Make a Planning Appeal

WEBLRD6093/26-S3B

MILLTOWN PARK, SANDFORD ROAD,
DUBLIN 6,
Dublin
D06 V9K7
Ireland

Third Party planning appeal in respect of the decision of Dublin City Council to issue Notification of Intention to Grant Planning Permission, under planning application, reg. ref. WEBLRD6093/26-S3B, for proposed development comprising of: "... a large-scale residential development ... The development will principally consist of: "the demolition of c. 4,847.5 sq m of existing structures on site including Milltown Park House (880 sq m), Milltown Park House Rear Extension (2,031 sq m), the Finlay Wing (622 sq m), the Archive (1,240 sq m) and the Link Building between Tabor House and Milltown Park House Rear Extension to the front of the Chapel (74.5 sq m); the refurbishment and reuse of Tabor House (1,575 sq m) and the Chapel (768 sq m) and the provision of a single storey glass entrance lobby to the front and side of the Chapel (52 sq m); and the provision of 562 No. residential units comprising 6 No. three-bed courtyard houses and 556 No. apartment units (70 No. studios, 176 No. one-bed units, 267 No. two-bed units and 43 No. three-bed units). Block A1 will range in height fr

Fig. 6: Block C maintains an approx. 95m wide west elevation up to 7 storeys

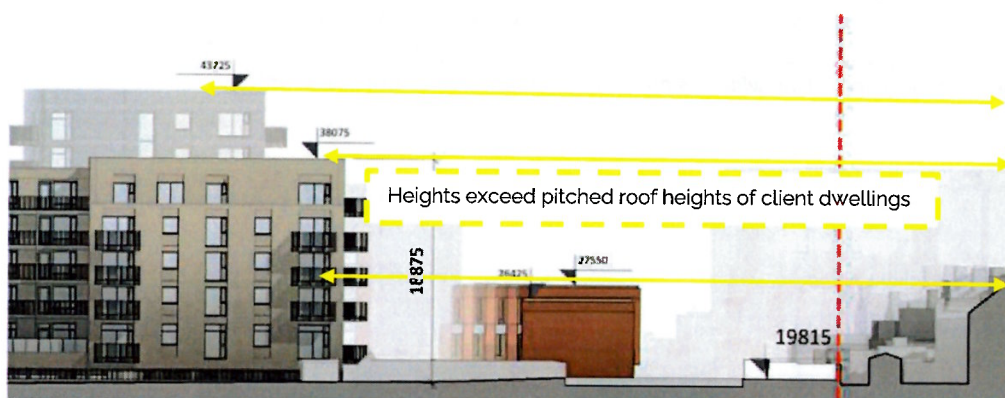
- Our client's residents consider that the proposed 5, 6 and 7 storey Block C is sited too close to their properties to allow anything above 4 storeys to be included. Block C represents substantial scale at this location. The 6th and 7th storeys would cause negative overbearing, visual dominance and visual obtrusion impacts on the existing 2 storey residential dwellings and rear gardens to the west. The building towers over even the apex of the pitched roofs of our client's residents' dwellings. Block C is over 95m wide.

To reduce negative visual overbearing/dominance/obtrusion impacts, the overlooking impacts and overshadowing impacts on our client's residents, Block C needs to be reduced to a 5 storey building – with 5 storeys maximum at its south end. This would provide a fair balance between our client's street and this new scheme. Block

Fig. 7: Siting of 4th and 5th storey overlooking windows and balconies relative to client properties

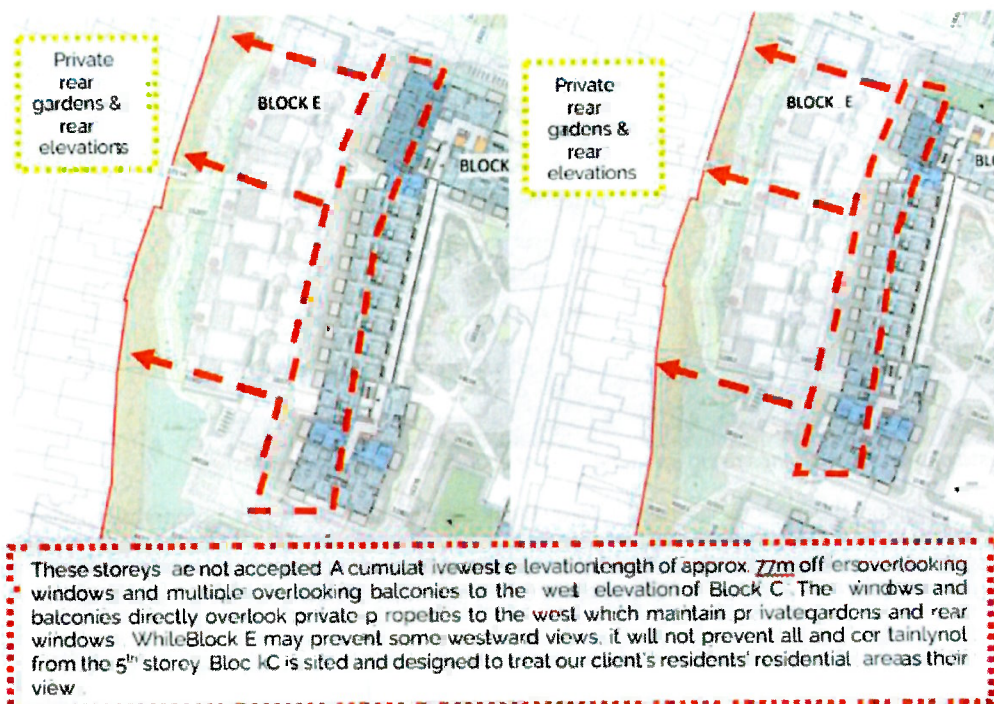
- ❖ **Storeys 1, 2 and 3** – These storeys are accepted.
- ❖ **Storeys 4 and 5** – These storeys are accepted but they will cause adverse impacts. A cumulative west elevation length of approx. 77m offers overlooking windows and multiple overlooking balconies to the west elevation of Block C. Some windows and balconies directly overlook private properties to the west which maintain private gardens and rear windows. While Block E may prevent some westward views, it will not prevent all and certainly not from the 5th storey. Block C is sited and designed to treat our client's residents' residential area as their view.

Fig. 9: Siting of 6th and 7th storey overlooking windows and balconies relative to client properties

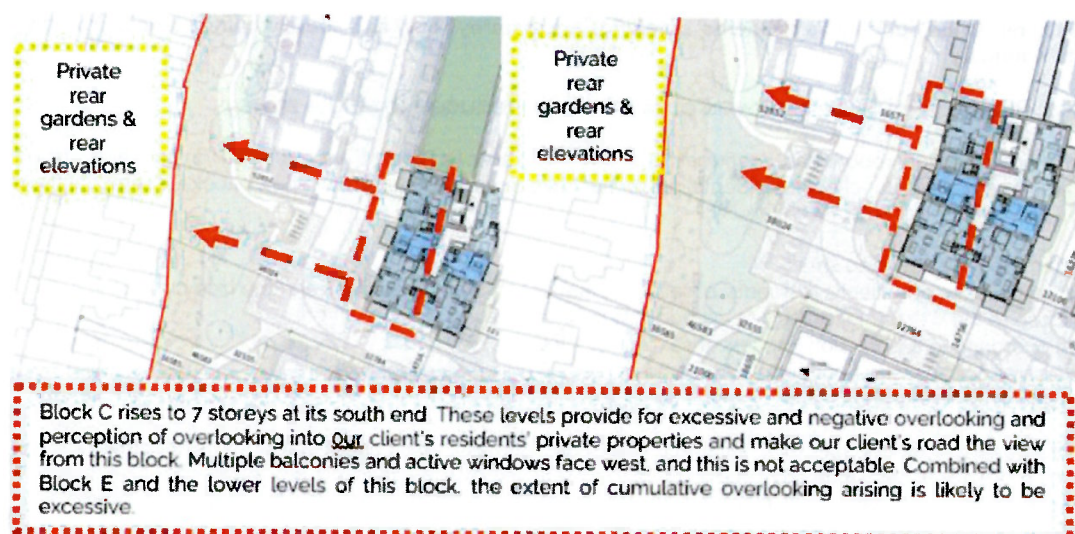
- ❖ **Storeys 6 and 7** – Block C rises to 6 and 7 storeys at its south end. These storeys are not accepted. They should be removed. Both levels provide for excessive and negative overlooking and perception of overlooking into our client's residents' private properties and make our client's road the view from this block. Multiple balconies and active windows face west, and this is not acceptable. Combined with Block E and the lower levels of this block, the extent of cumulative overlooking arising is likely to be excessive.

Fig. 14: The setback area is misleading and poorly considered

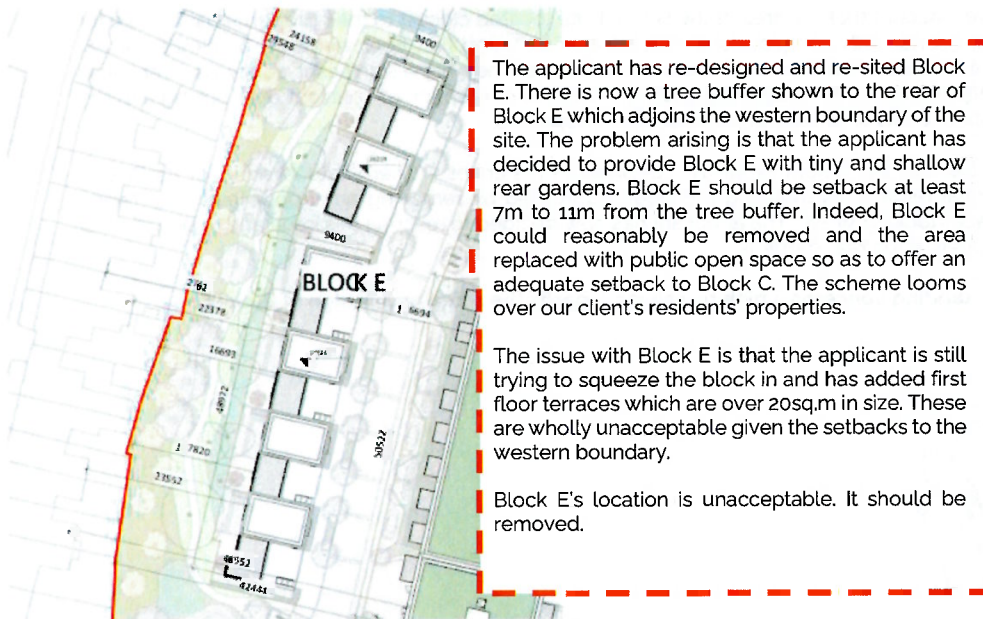
- The issue with Block E is that the applicant is still trying to squeeze the block in and has added first floor terraces which are over 20sq.m in size. These are wholly unacceptable given the setbacks to the western boundary. Block E's location is unacceptable. It should be removed. Our client's residents would face a Block E whose total cumulative length is 70m to 75m. While there is a small break in the middle of the block, this would only perhaps be visible by those properties directly to the west. Most would view Block E as an unbroken continuous block. This continuous block maintains first floor terraces spaced out at intervals along the first floor. The applicant is essentially proposing viewing galleries into our client's residents' properties. These terraces are not acceptable and should be removed. Block E is not acceptable as proposed. The block is too close to the boundaries to the west, too long, and contains first floor terraces.

Fig. 30: The setback area is too thin and does not offer sufficient mitigation to Block D

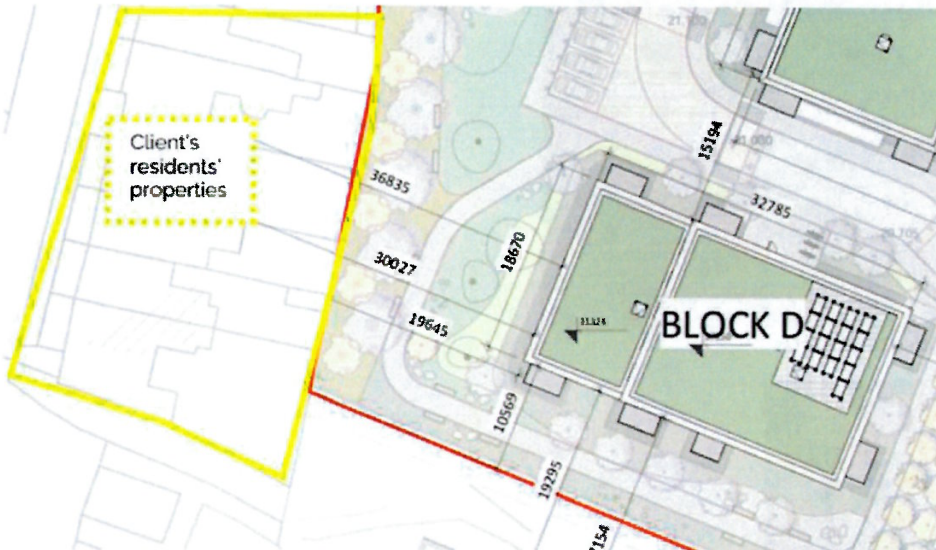
Our client's residents object to how the applicant has decided to provide setbacks from the western boundary to Block D of a minimum of 19.465m. The standard rear garden depth of a two storey dwelling is generally 11m. The proposed setbacks from this apartment block are approx. this but this is a large apartment block. Such a limited setback distance is unacceptable. It fails to offer any sufficient mitigating distance to ameliorate amenity impacts arising for our client's residents' properties.

ACP is asked to require that Block D be amended to provide an improved compromise between the applicant's ambitions and the rights of adjoining properties to expect their established residential and visual amenities to be protected.

Fig. 32: Scale of client properties relative to Block D

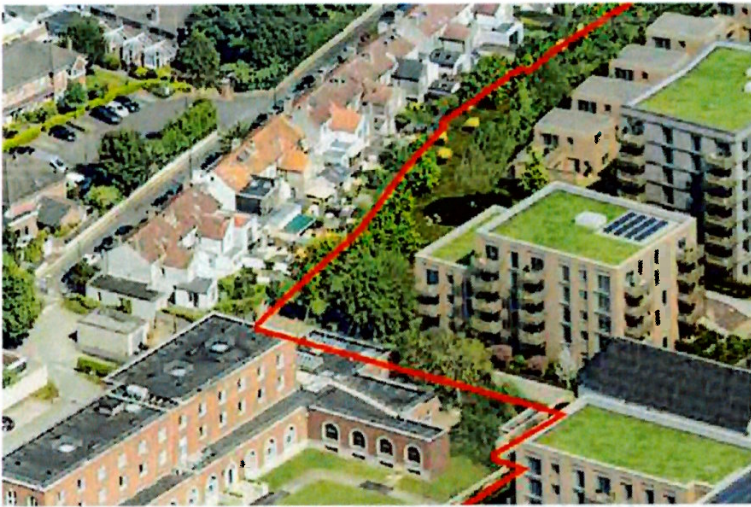
Our client's residents would face a Block D whose west elevation is 16.67m wide or 19.69m wide (with 1.5m wide side balconies added) and which extends initially to 3 storeys at 11.030m tall and then to 5 storeys at 16.955m tall. While there is a setback to levels 4 and 5, the 3rd storey is simply too tall at its proposed location. Block D should be 2 storeys and then 4 storeys. Block D is not acceptable as proposed. The block is too close to the boundaries to the west, too tall and too over-scaled to be sited as proposed.

Fig 11: Bike/bin store to the north of Block E contrary to ACP decision reg. ref. ABP-311302-21 (LRD1)

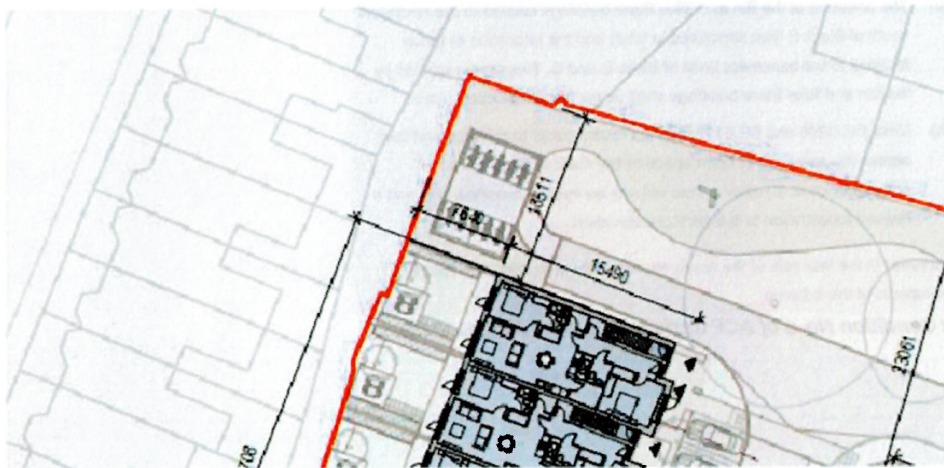
Many observers at Cherryfield and Norwood are critical of the location of the bike/bin stores and anticipate high levels of nuisance from noise and odour. I agree that the location of bike/bin stores at the north and south ends of Block E are haphazard and appear as an afterthought. According to the applicant, the position of the bike/bin stores has been chosen to suit the future occupants and servicing requirements of the development. However, I think that a more suitable location could have been selected that did not impact upon neighbouring properties, the basement level of Block B/C for example. In the interests of preserving residential amenity, I recommend the relocation of these bike/bin stores to a more suitable and better integrated location within the site.

Fig. 29: The scheme's public open space design is unbalanced and unfair to the west of the site

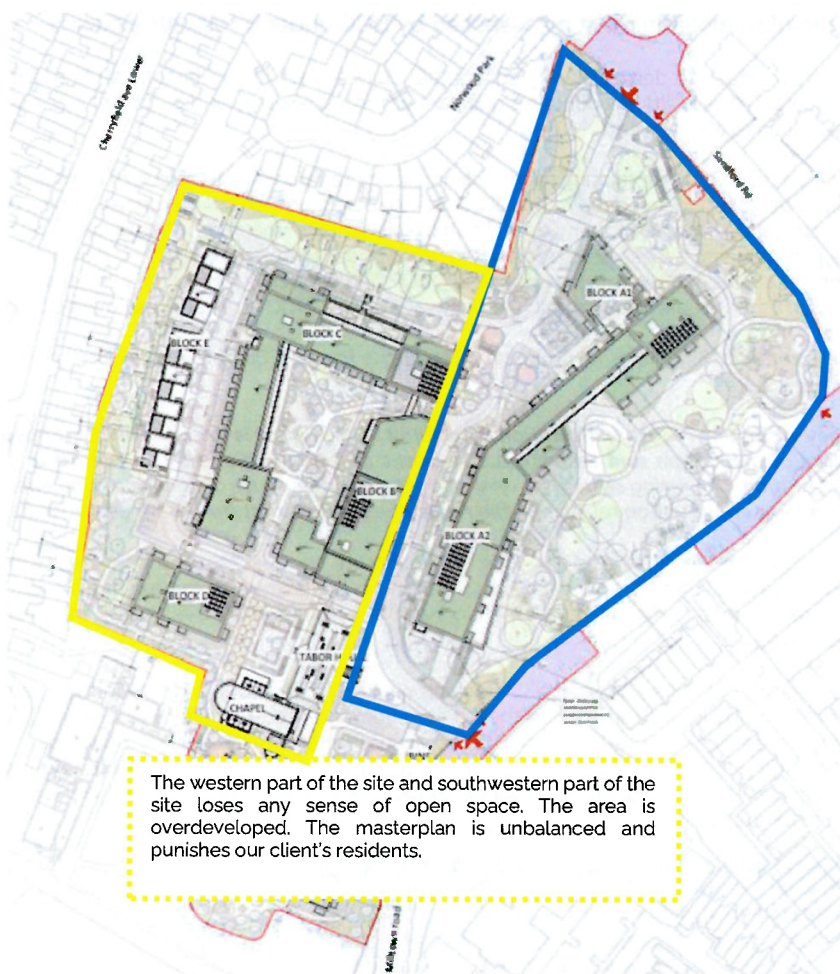
A revised masterplan layout is required to address the unbalanced and unfair distribution of public open space to the west of the site. There should be a larger and permanent public open space corridor along the western boundary of the site with new planting to enhance the tree belt that exists at this location.

Fig. 54: The setback area is too thin and does not offer sufficient mitigation to Block D

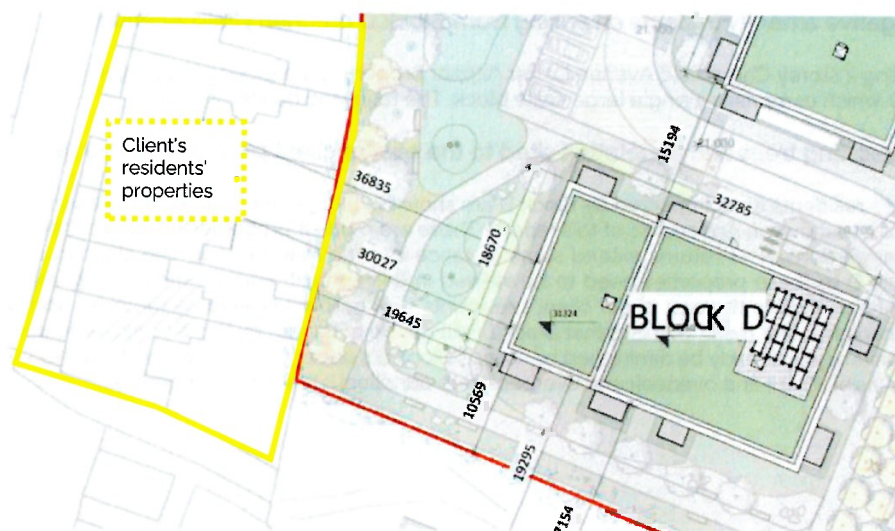
Our client's residents object to how the applicant has decided to provide setbacks from the western boundary to Block D of a minimum of 19.465m. The standard rear garden depth of a two storey dwelling is generally 11m. The proposed setbacks from this apartment block are approx. this but this is a large apartment block. Such a limited setback distance is unacceptable. It fails to offer any sufficient mitigating distance to ameliorate amenity impacts arising for our client's residents' properties.

Fig. 58: Siting of 3rd storey overlooking windows and balconies relative to client properties

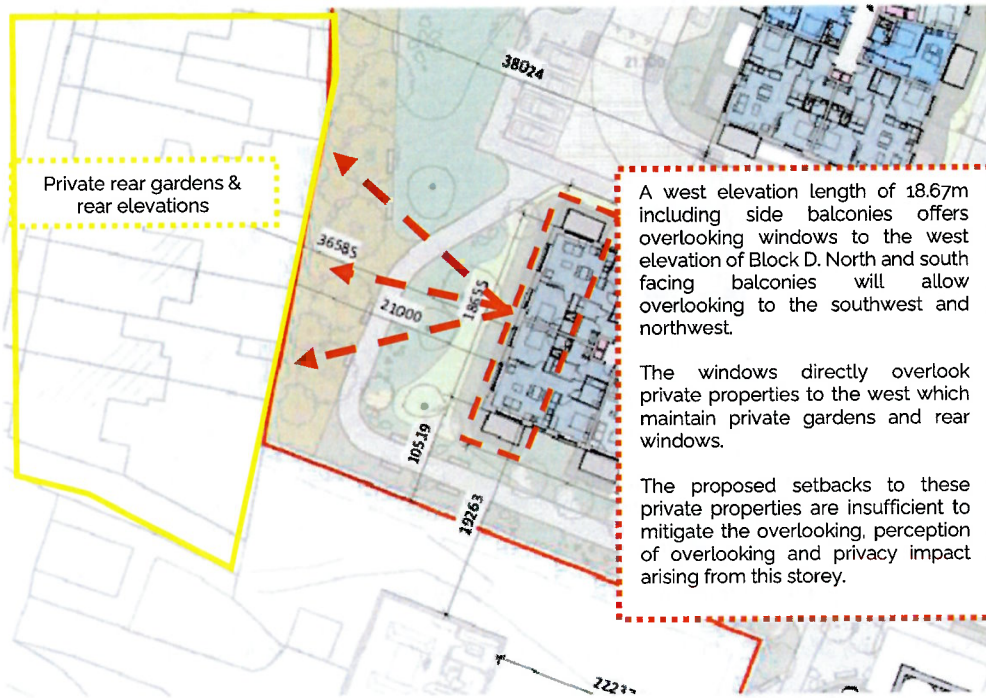
overlooking to the southwest and northwest. The windows directly overlook private properties to the west which maintain private gardens and rear windows. The proposed setbacks to these private properties are insufficient to mitigate the overlooking, perception of overlooking and privacy impact arising from this storey (see Fig. 58). This storey should be removed and replaced by the setback 4th storey.

Fig. 59: Siting of 3rd and 4th storey overlooking windows and balconies relative to client properties

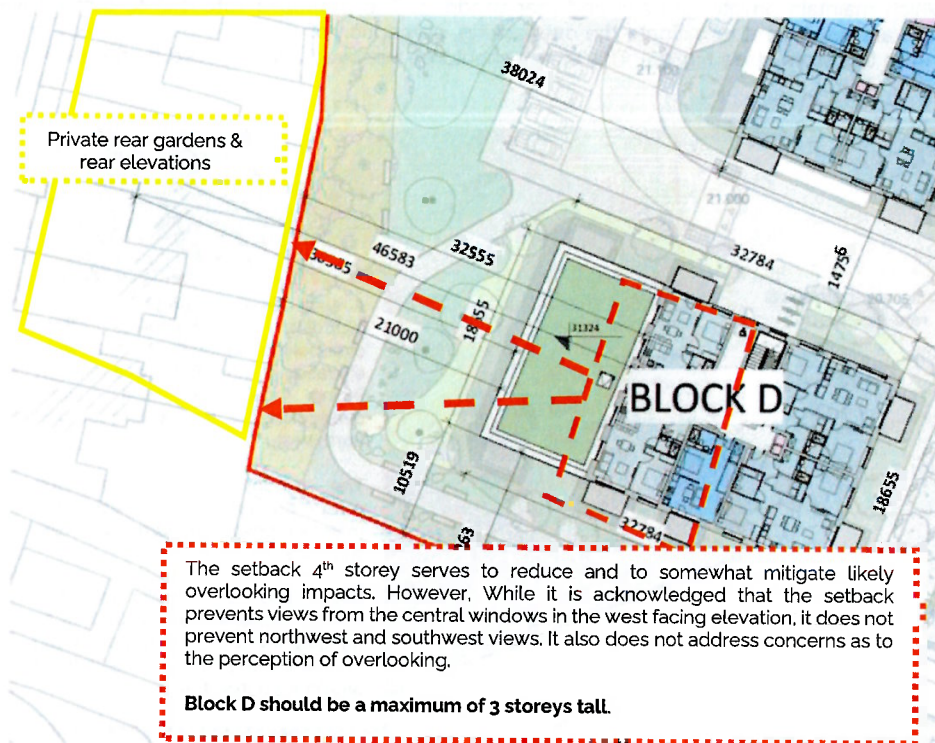
Storeys 4 and 5 – These setback storeys are not accepted as a 4th storey; however, one would be acceptable as a 3rd storey in a 3 storey only building. While it is acknowledged that the setback to the 4th storey prevents views from the central windows in the west facing elevation, it does not prevent northwest and southwest views from living room windows and balconies (on the north and south elevations). The setback does not prevent downward views from the 5th storey windows and balconies (see Fig. 59). It also does not address concerns as to the perception of overlooking.

Fig. 61: Block D's 3 story section proposed shadow at 8am on March and September 21st

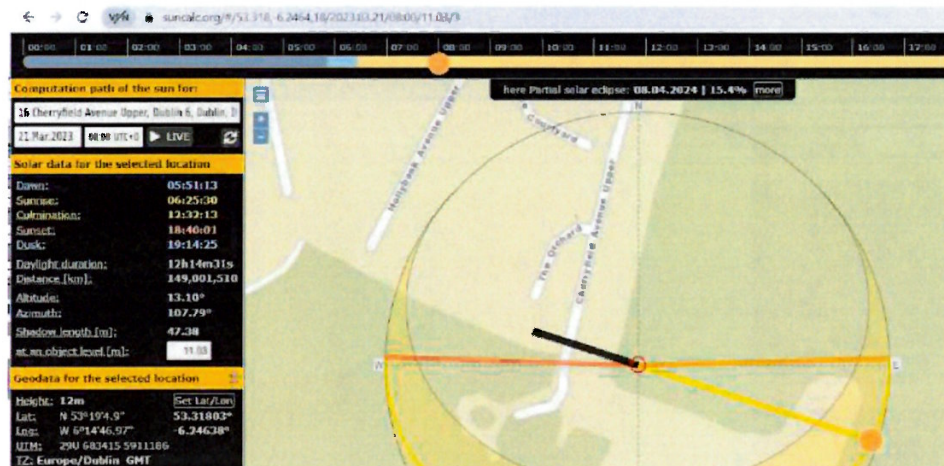
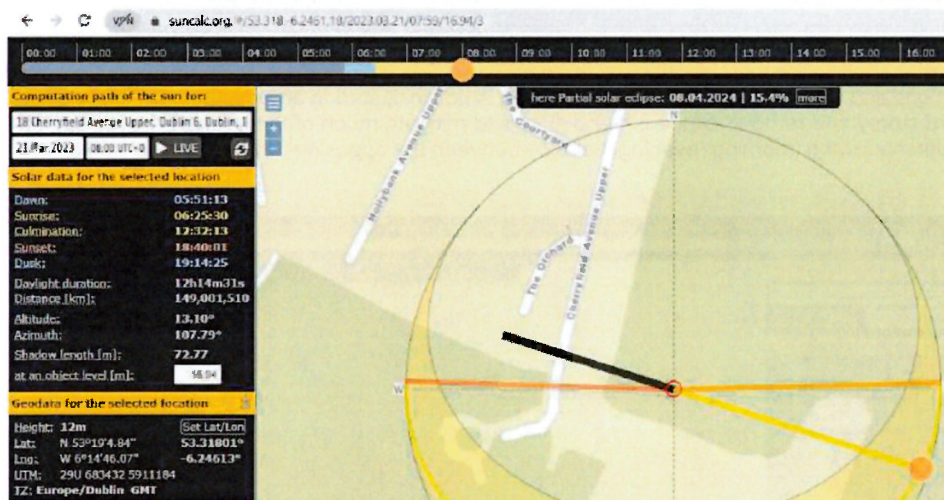
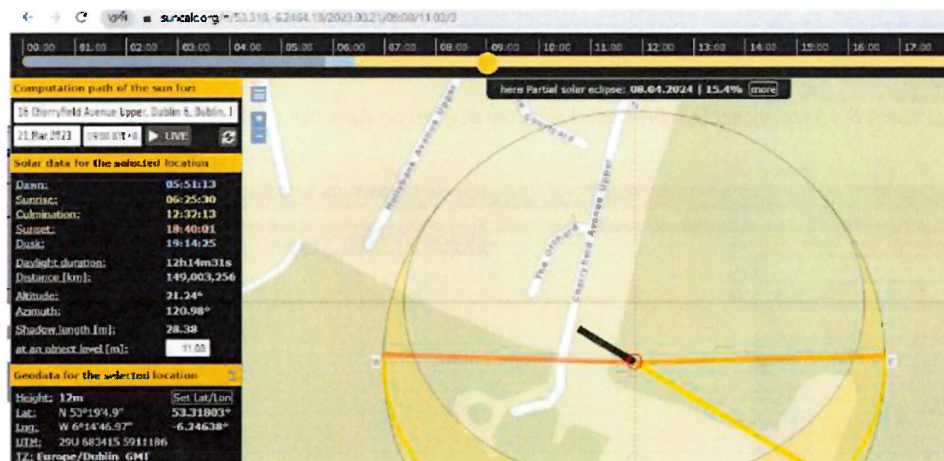
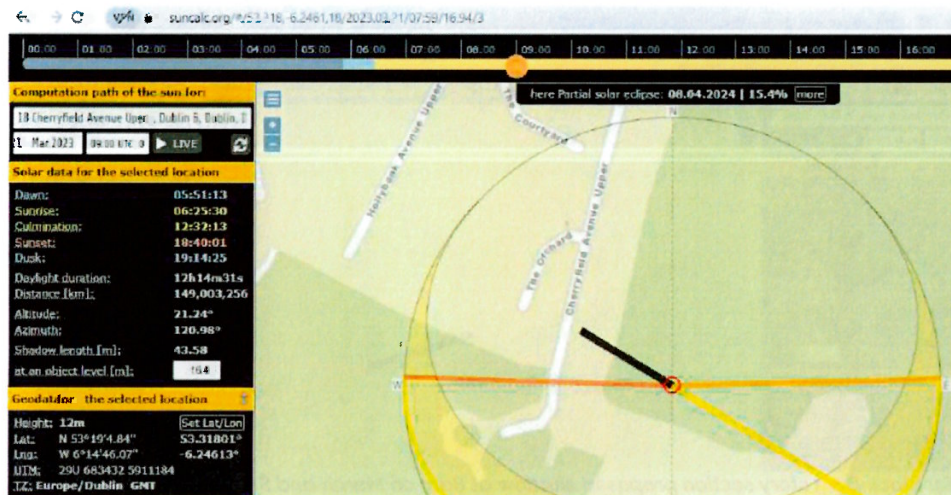
March and September 21st: From sunrise until nearly 10am, Block D would cause overshadowing of our client's residents properties sited to the west, southwest and northwest. This overshadowing would impact private rear elevations and rear gardens. This overshadowing is not mitigated in any manner. The setting back of the 3rd storey and removal of the 4th and 5th storeys would mitigate much of the overshadowing such that a fair overshadowing (morning/evening) balance between the opposing properties is achieved.
